LDC and the 14 mrad Crossing Angle

LDC General Phone Meeting
24. August 2006

BDS Change Request

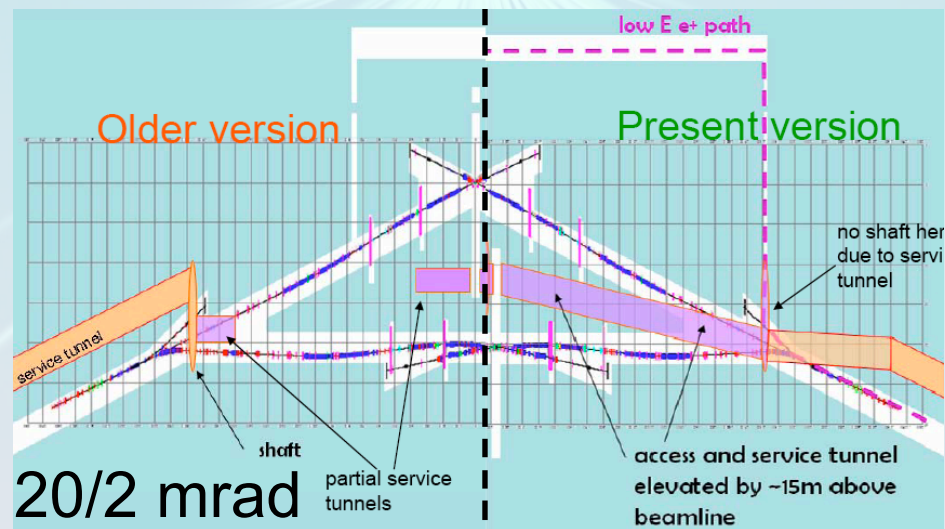
- Beam Delivery System change request
 - Submitted on July 29th to the CCB
- Changing the baseline from 2/20 mrad crossing angles to a symmetric configuration of 14/14 mrad
- Both detectors will be placed at the same longitudinal position ($z=0$) in one detector hall
- Reason: substantial cost savings
